Graham and Peta Butson
5/42 Victoria Parade Manly

Attention: Development Assessment
Planner: Renee Ezzy

MODIFICATION APPLICATION: MOD 2019/0029
DA367/2010
46 VICTORIA PARADE, MANLY

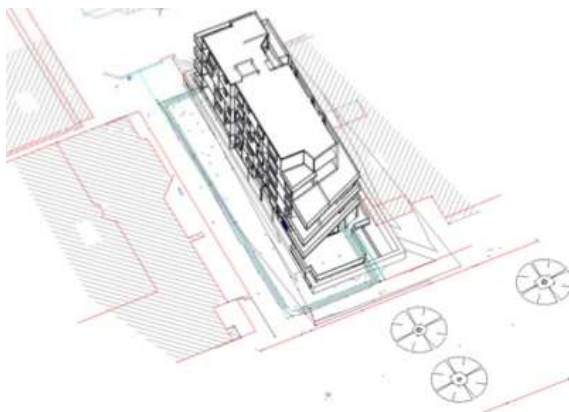
The roof and the floor level heights have all been changed.

There is no justification for the change in the design of the roof and floor heights as approved by the LEC and MIAP on 21st August 2014. Our owners had to spend considerable time, effort and money in order to receive a fair outcome to prevent overshadowing of our building.

The roof plan, S96:200 of the 2014 DA was redesigned again on 28 May, Issue C, in order to provide sunlight to Units 5, Level 1, and Unit 1, on the Ground. The 2019 Plans for Roof and West Elevation Level 4 still reduce sunlight to the Ground Level, and Level 1 of our building, especially at 12pm as seen in the table below:

- **the 600mmm setback continue to the southern boundary,**
- **the length of the open space be reinstated to that approved by MIAP,**
- **the wings be reinstated for the roof cutout as per MIAP,**
- **the floor height RL17.265 for Level 4 be reinstated, or add a slope on the leading edge in the cutout on Level 4 at RL17.265.**
